CONTRACT CHANGE ORDER NO. _____
SHEET ____ OF ____

SAN FRANCISCO OAKLAND BAY BRIDGE
EAST SPAN SEISMIC SAFETY PROJECT
SELF-ANCHORED SUSPENSION BRIDGE
(SUPERSTRUCTURE & TOWER)

TYPICAL FLOORBEAM DETAILS NO.1

TYPICAL FLOORBEAM DETAILS NO. 4A

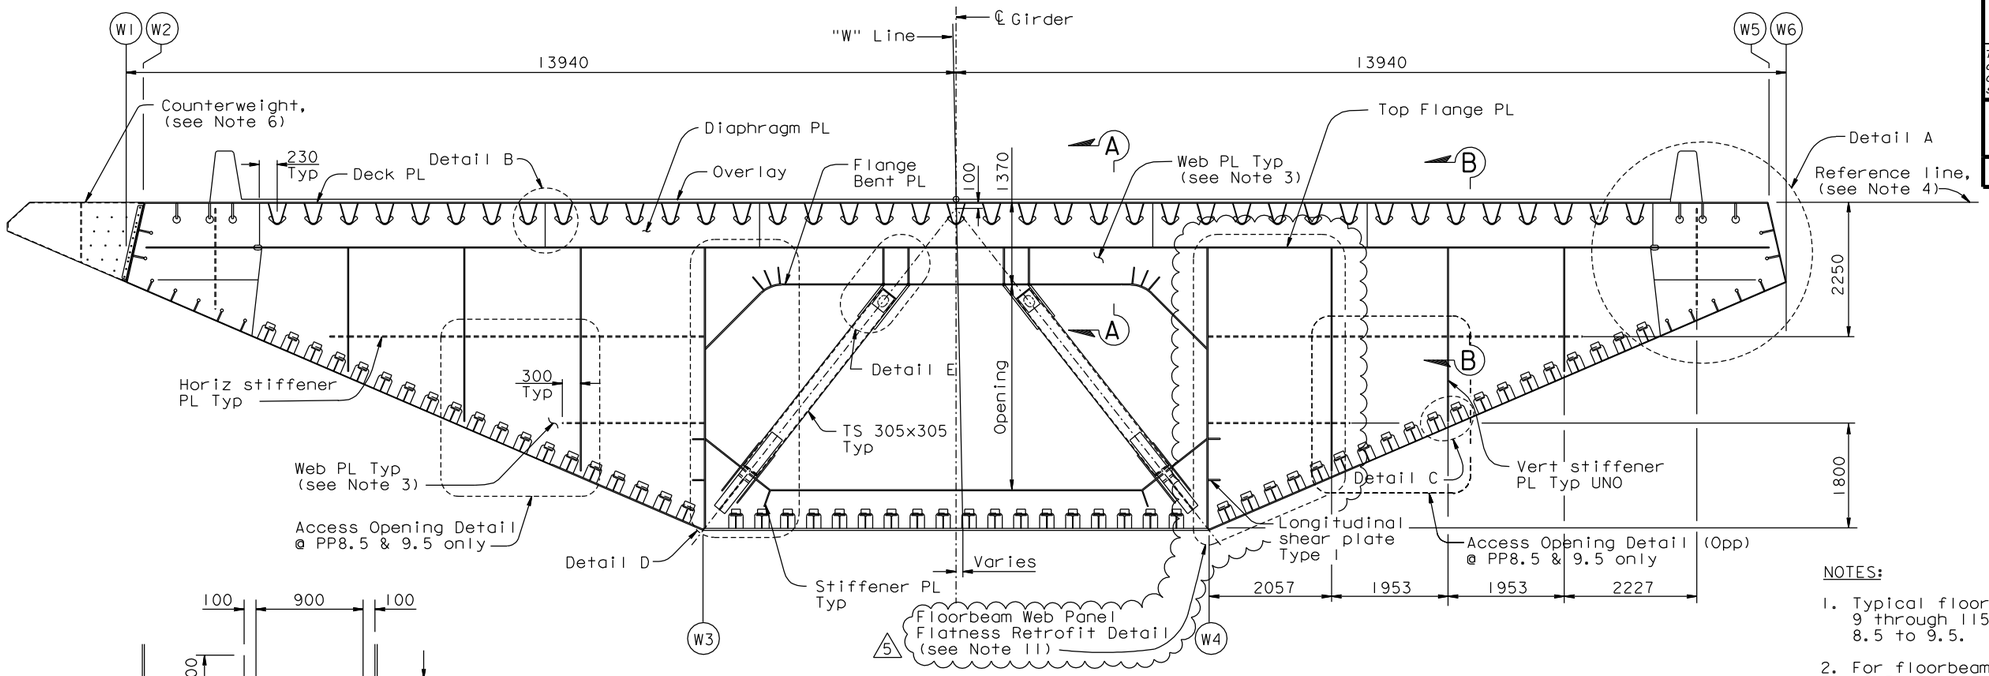
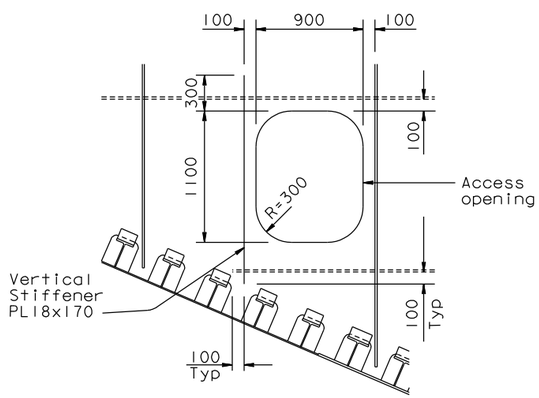
9. For Detail A, see "Typical Floorbeam Details No.3" sheet.
10. For Details D and E, see "Typical Floorbeam Details No.5" sheet.
11. (5) For web PL "Floorbeam Web Panel Flatness Retrofit Detail" for out-of-tolerance floorbeam web panels (E & W Lines), see "Typical Floorbeam Details No.4A" sheet.

MARK	DATE	DESCRIPTIONS	BY	CH'D	CCO#
5	07/14/11	FLOORBEAM DIAPHRAGM	GB	DT	143
4	04/08/09	GRINDING OBG DECK PLATES	AS	DT	53
3	04/30/08	GRINDING OBG DECK PLATES	AS	DT	53
2	01/22/08	GRINDING OBG DECK PLATES	AS	DT	53
1	02/16/07	BULKHEAD AT GIRDER PIER W2	AS	DT	27

DIAPHRAGM RETROFIT DETAIL (See Notes 1 and 4)

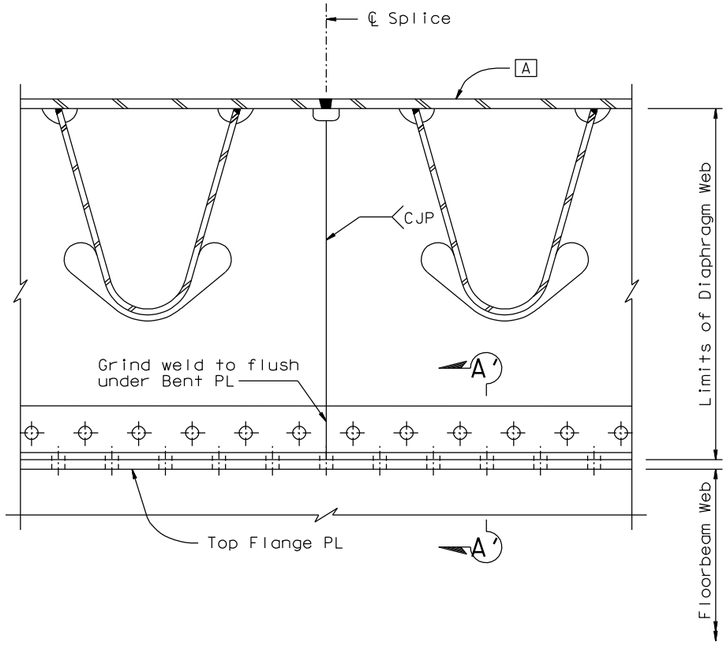
1. Floorbeam diaphragm web plate distortion resulting from fabrication methods and application of heat straightening shall be repaired following the guidelines provided in "Heat Distortion Repair Criteria for Diaphragm Plate" Table below, the "Diaphragm Retrofit Detail" and the "Floorbeam Web Panel Flatness Retrofit Detail" provided on this sheet. Approval of the Engineer is required prior to repair.

MARK	DATE	DESCRIPTIONS	BY	CH'D	CCO#
0	08/02/11	FLOORBEAM DIAPHRAGM	GB	MN	143

CASE	DISTORTION RANGE (△)	APPLY HEAT STRAIGHTENING	APPLY DIAPHRAGM RETROFIT DETAIL	ADDITIONAL 100% NDT
A	△ > 30 mm *	Required to bring △ to less than 30 mm	Pending results of heat- straightening, see Case B or C	Required
B	10 mm < △ ≤ 30 mm	Optional in lieu of Diaphragm Retrofit	Required if not heat-straightened	Required if heat straightened
C	△ ≤ 10	Not required	Not required	Not required

2. Radius of Bent PL may be increased to clear additional weld reinforcement, if any.
3. The "Floorbeam Web Panel Flatness Retrofit Detail" shall be used to correct out-of-tolerance floorbeam web panel flatness as directed by the Engineer.
4. Retrofit applicable only when diaphragm to web misalignment "e" at floorbeams is within the specified tolerance, see "Typical Floorbeam Details No. 9" sheet. For "e" outside tolerances, retrofit shall be as directed by the Engineer.

DETAIL C (See Note 4)
NTS

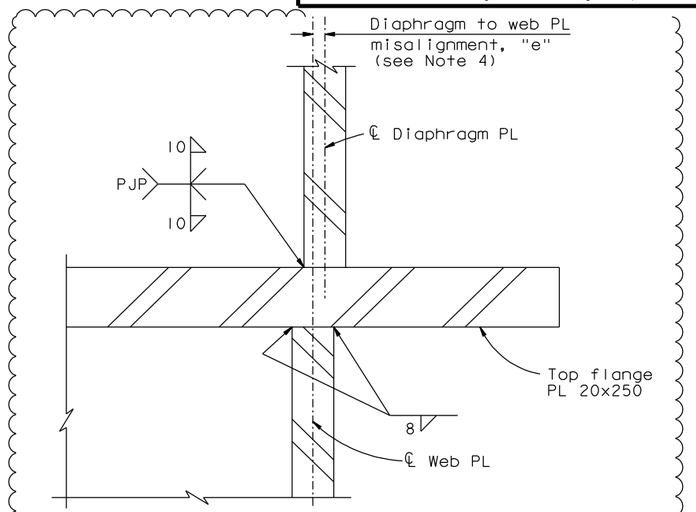
1. For Sections C-C and D-D, see "Typical Floorbeam Details No. 3" sheet.
2. Section A-A is typical at all floorbeams that do not have Chevrons, including floorbeams in east transition. For these locations, see "Floorbeam At East Transition" sheets and Detail C.
3. For termination of diaphragm edge plate and fin edge plate, see "Typical Girder Details No. 16" sheet.
4. The alternate weld detail for diaphragm to floorbeam web connection shown in Detail C is acceptable on a fit-for-purpose basis to allow an increase in diaphragm to web plate misalignment, "e", of up to 10 mm at floorbeams and intermediate floorbeams in east transition spans.

MARK	DATE	DESCRIPTIONS	BY	CH'D	CCO#
1	08/02/11	FLOORBEAM DIAPHRAGM	GB	MN	143
